AGENDA

PLANNING & ZONING COMMISSION REGULAR MEETING TUESDAY, FEBRUARY 4, 2025 - 3:00 PM MCALLEN CITY HALL, 1300 HOUSTON AVENUE CITY COMMISSION CHAMBERS, 3RD FLOOR

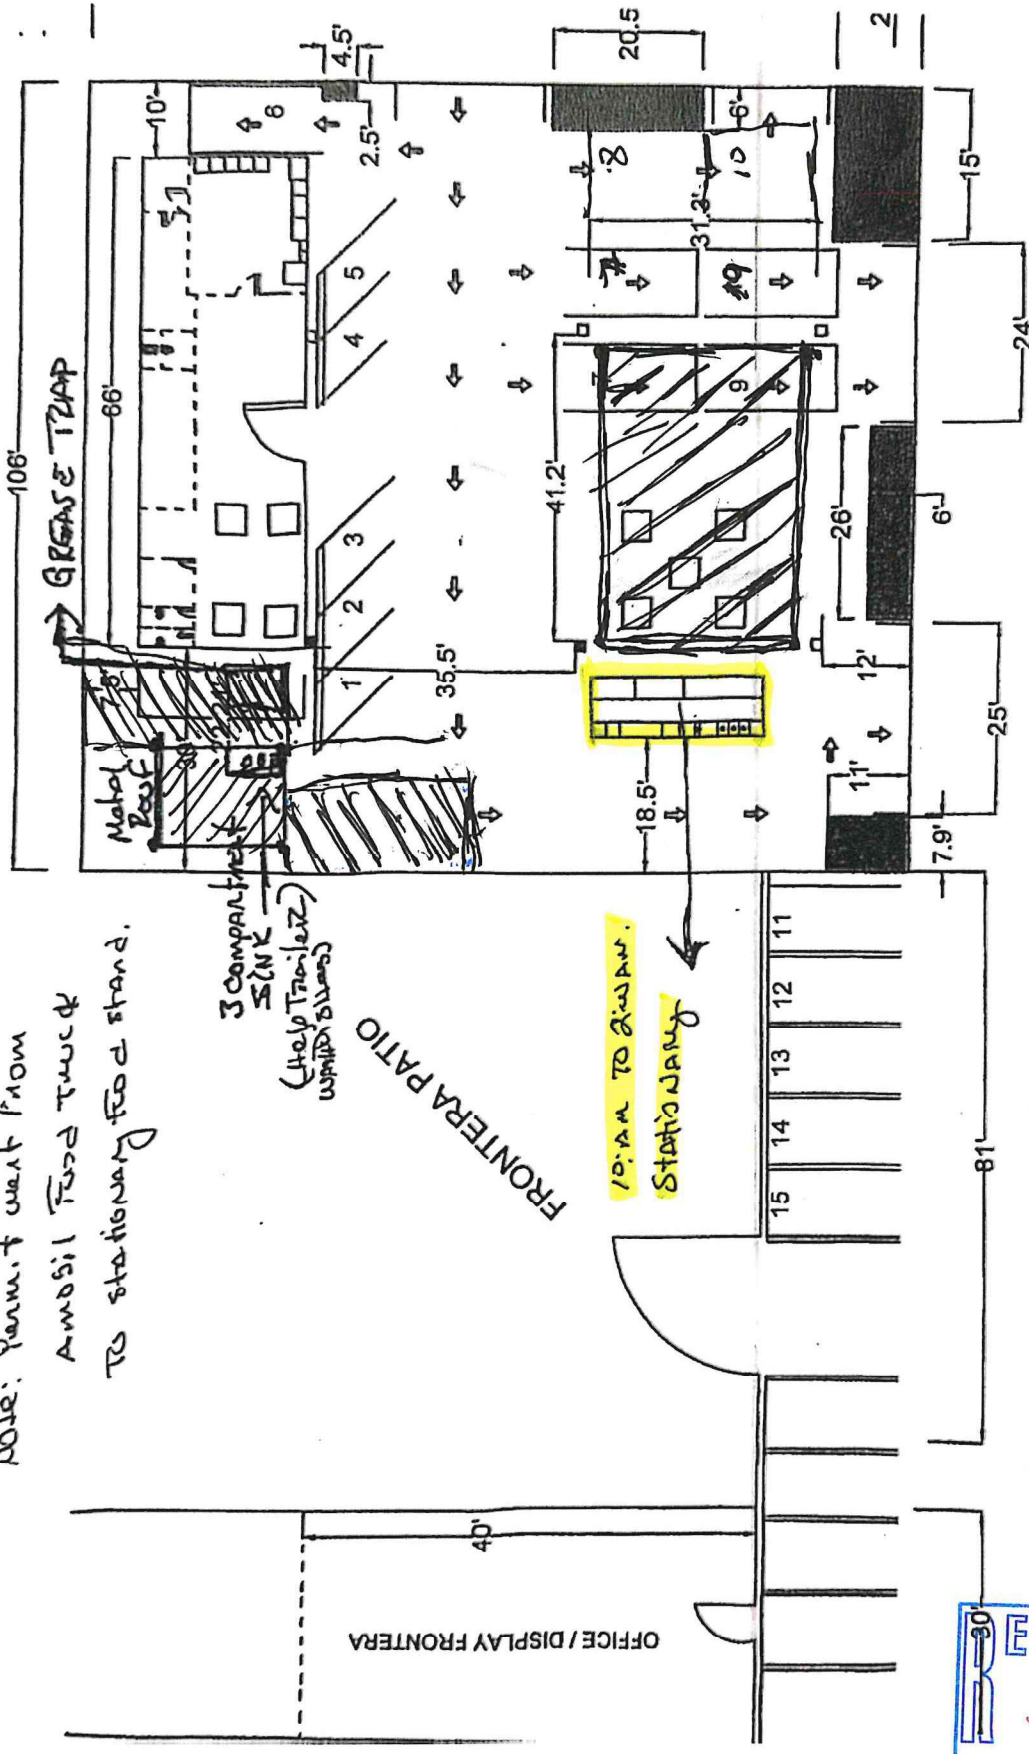
ANALYSIS: The McAllen Zoning Ordinance Section 138-395 subsection (14) states that a restaurant, nightclub, cafe or similar recreation or amusement establishment request one parking space for each 100 square feet of floor area, or one space for each five seats, whichever is greater. Based on the submitted site plan, three areas make up this establishment. An enclosed structure (1,118.25 square feet in floor area) used as a dining

area, the main building of the property (1,440 square feet in floor area), and lastly, the portable food concession stand. The required parking for this establishment is 26 parking spaces. There are 16 proposed parking spaces as per the site plan, 10 are provided within the subject property and six are being proposed as part of a parking agreement with the neighboring business "Frontera Collision Auto Parts". The applicant has stated that he will obtain additional parking spaces as necessary. Parking agreement document(s) have not been submitted. According to the applicant, no drive-thru services are available.

Staff recommends disapproval of the request, due to non-compliance with parking requirements.

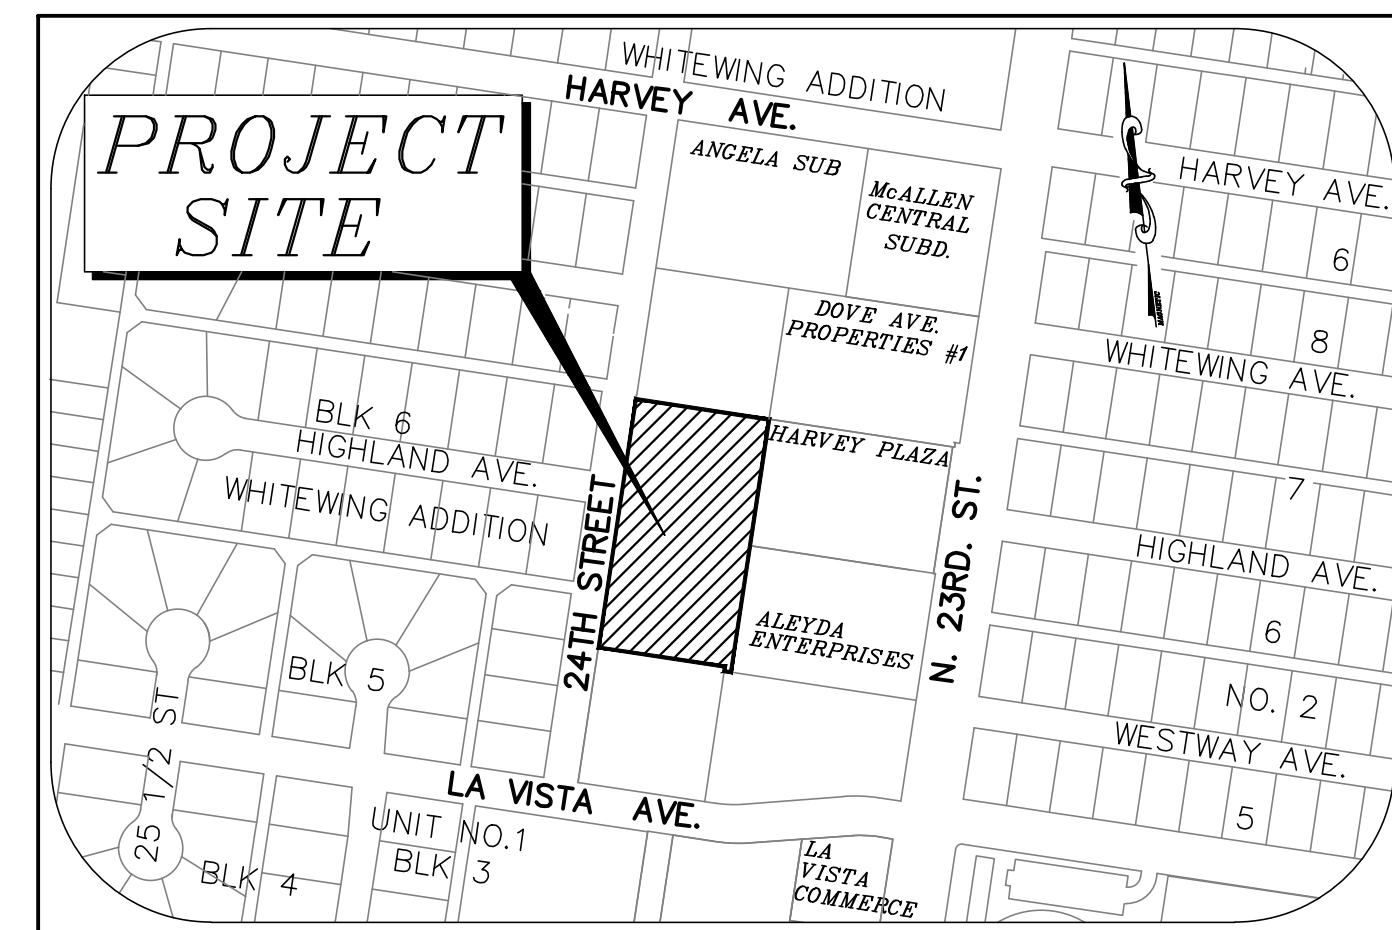
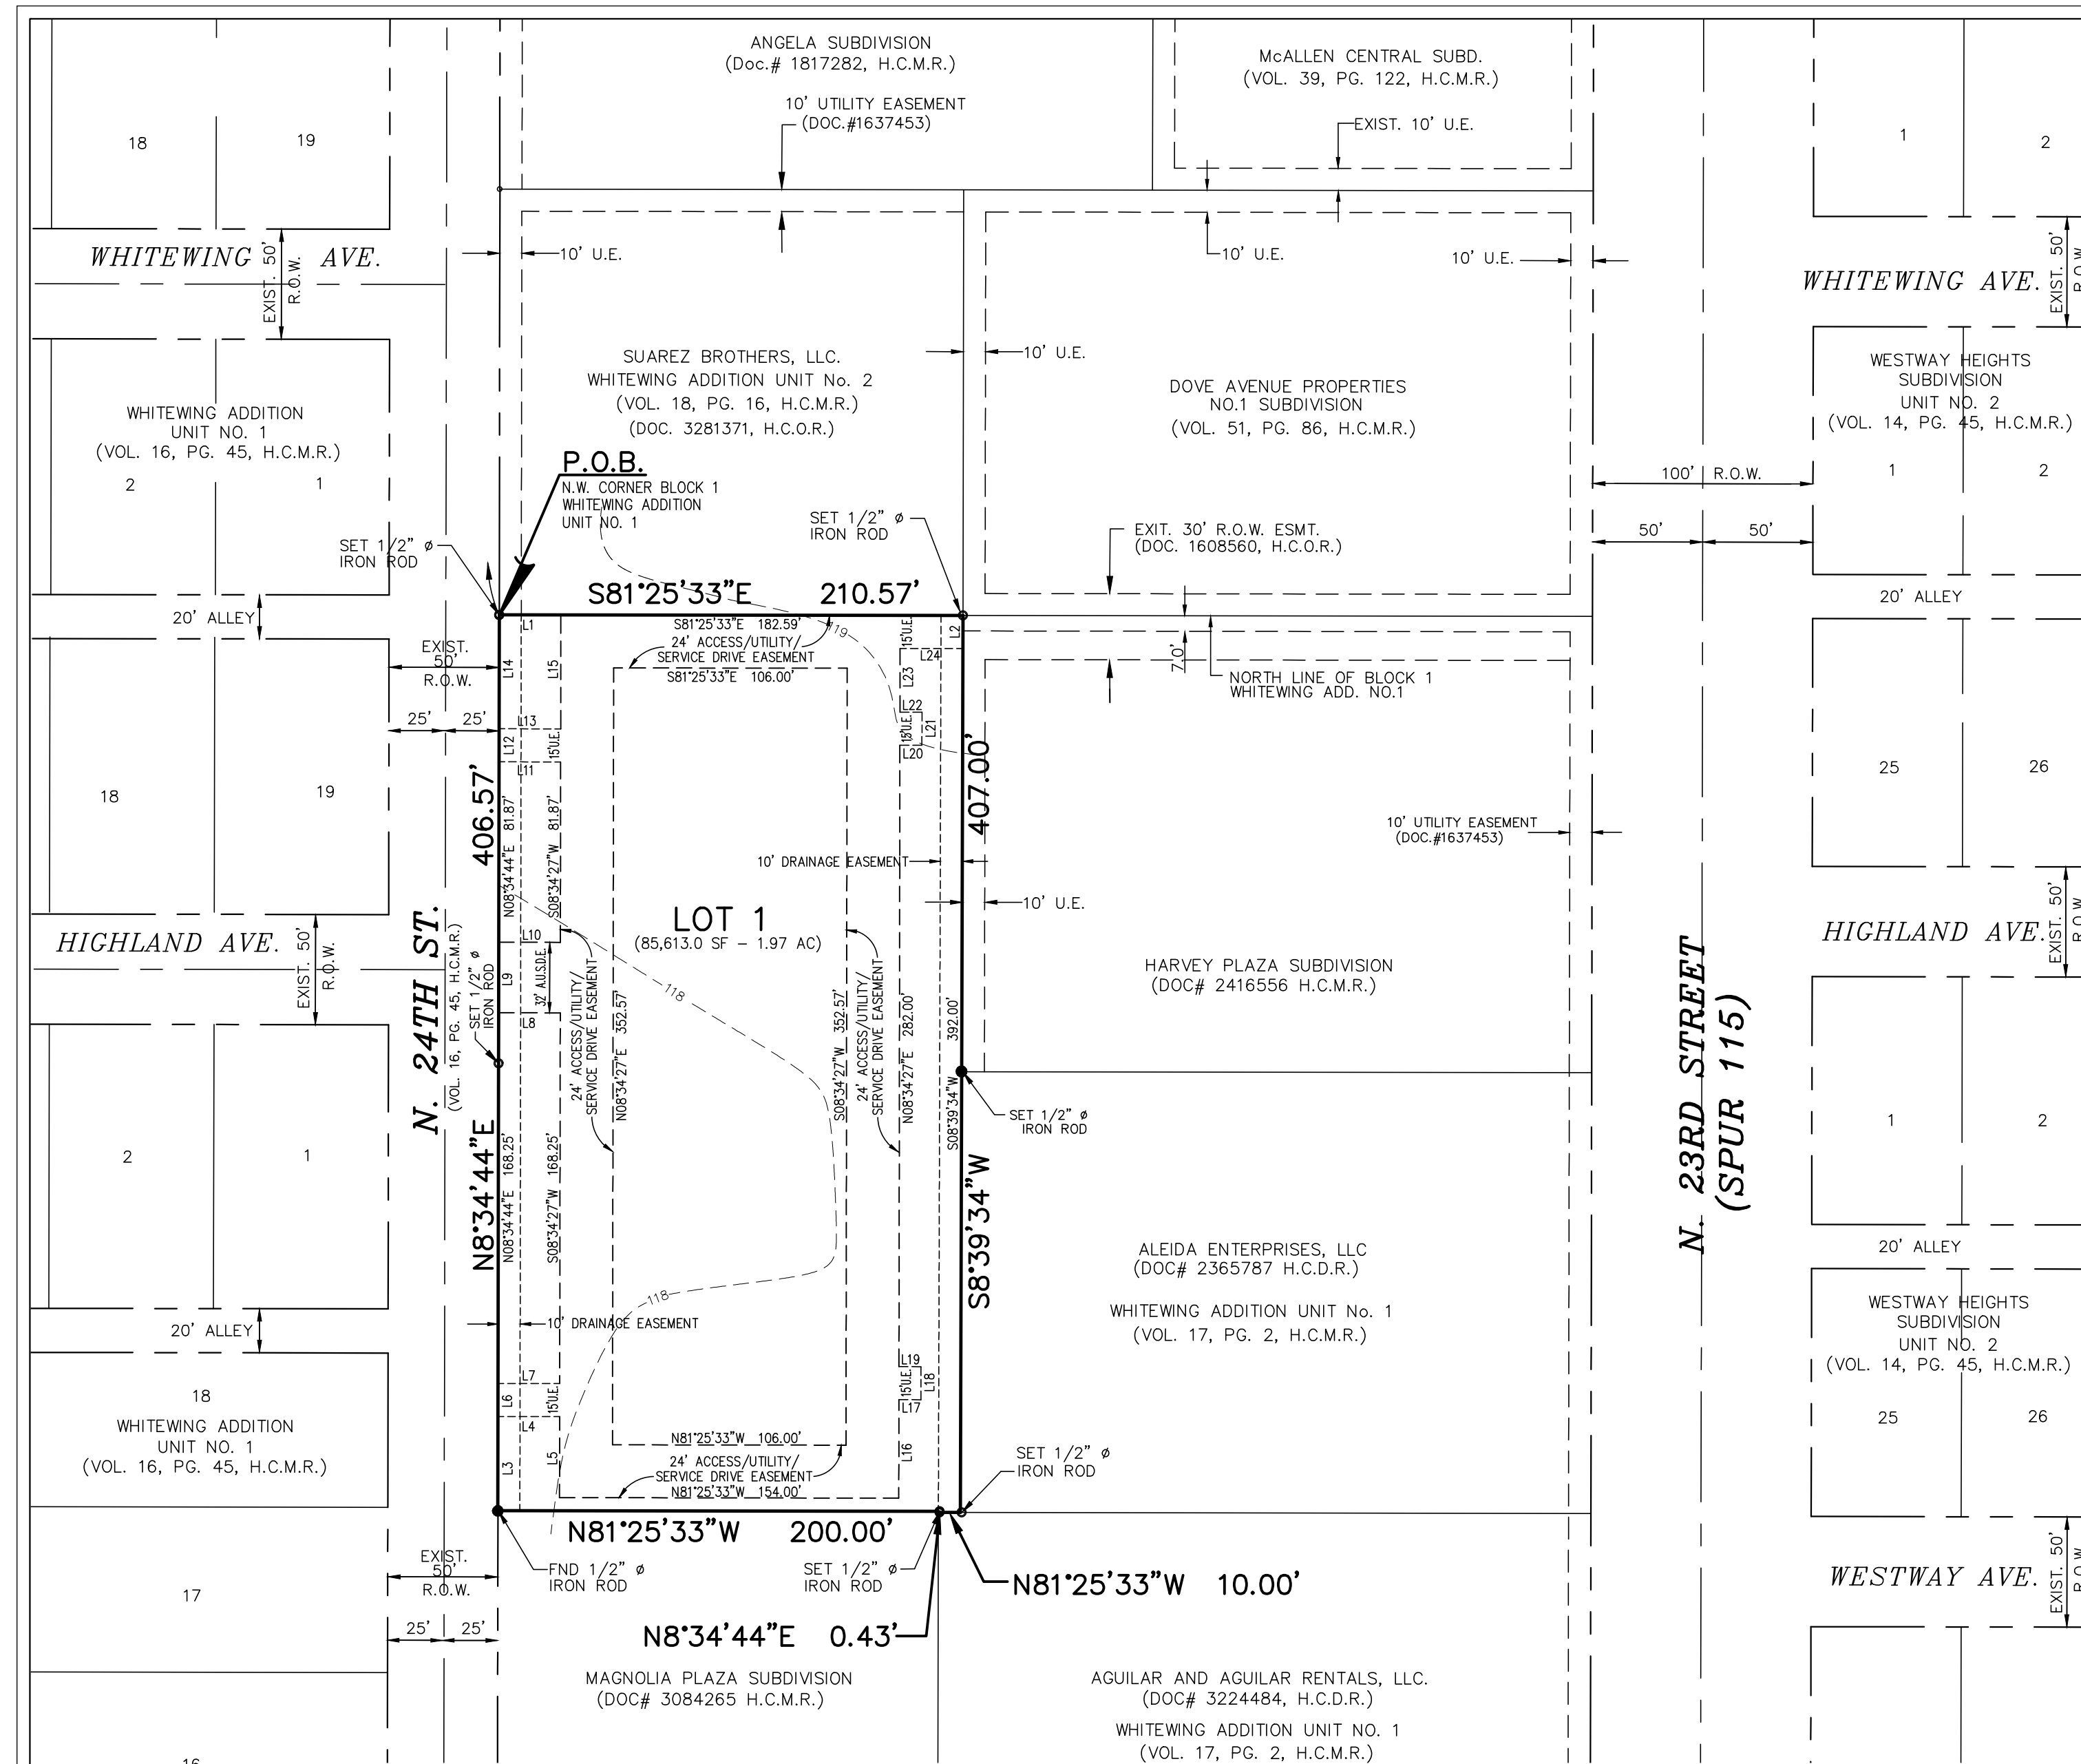
SUBDIVISION NAME: SUAREZ SUBDIVISION	
REQUIREMENTS	
STREETS AND RIGHT-OF-WAYS	
North 24th Street: 25 ft. from centerline for 50 ft. total ROW Paving: 32 ft. Curb & gutter: both sides **Subdivision Ordinance: Section 134-105 **Monies must be escrowed if improvements are required prior to recording. **COM Thoroughfare Plan	Applied

* Front: In accordance with the Zoning Ordinance or greater for approved site plan or easements or inline with existing structures, whichever is greater applies. **Zoning Ordinance: Section 138-356	Applied

* Rear: In accordance with the Zoning Ordinance or greater for easements or approved site plan, whichever is greater applies. **Zoning Ordinance: Section 138-356	Applied

* Sides: In accordance with the Zoning Ordinance or greater for easements or approved site plan, whichever is greater applies. **Zoning Ordinance: Section 138-356	Applied
